PROJECT: THE WORLD TRADE CENTER | TITLE: REVISION AFTER FABRICATION -DETAIL 927 | DATE: 3-21-69

19-AB-927.

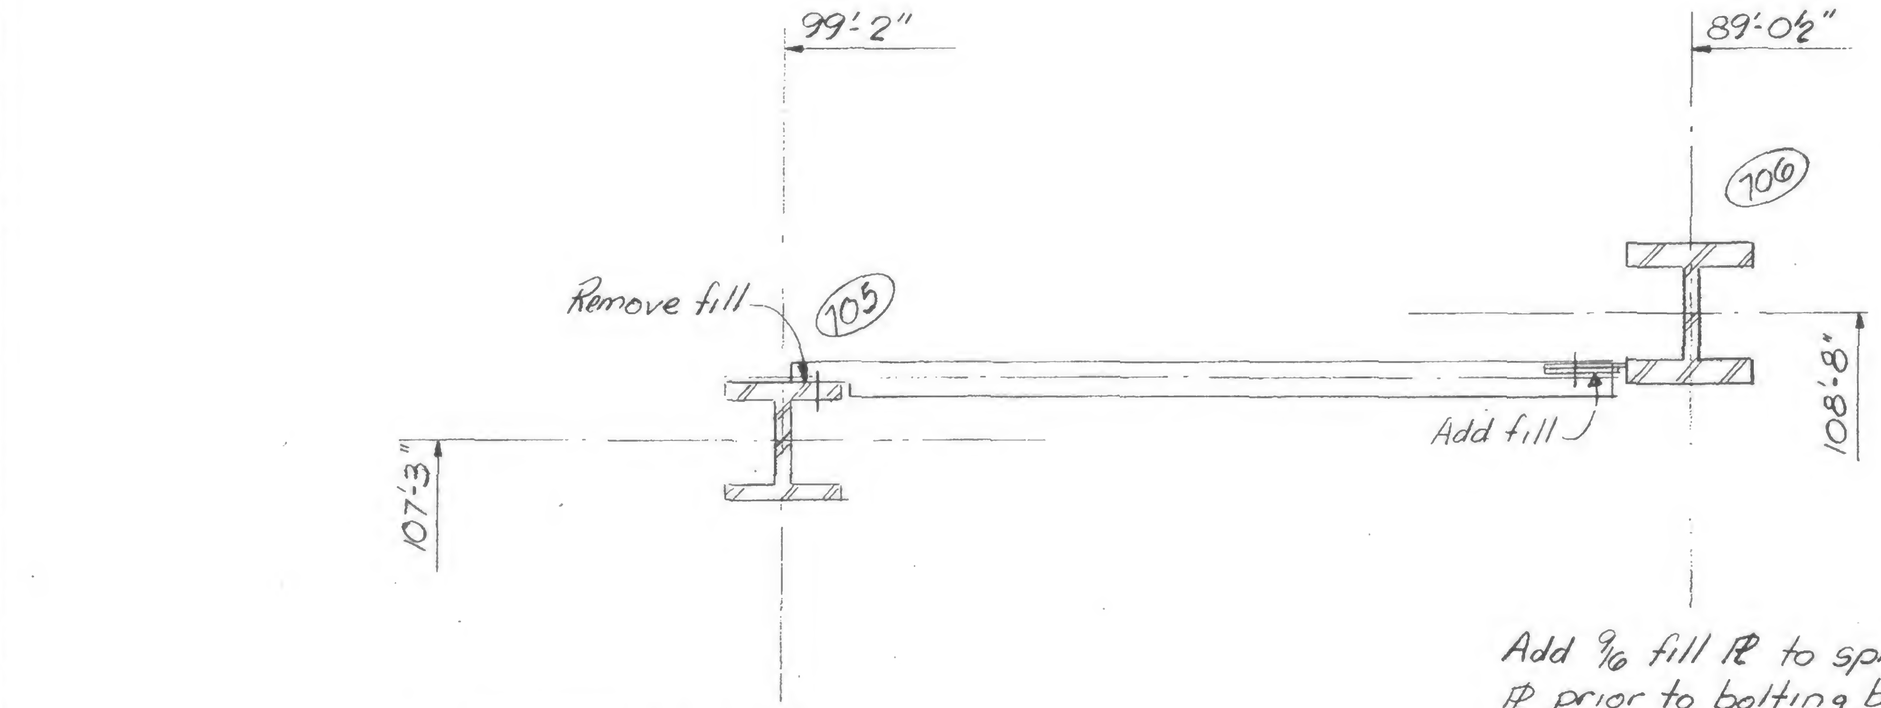
Remove 9/16" fill PL from flange of column and bolt beam directly to flange

Add 9/16 fill PL to splice PL prior to bolting beam
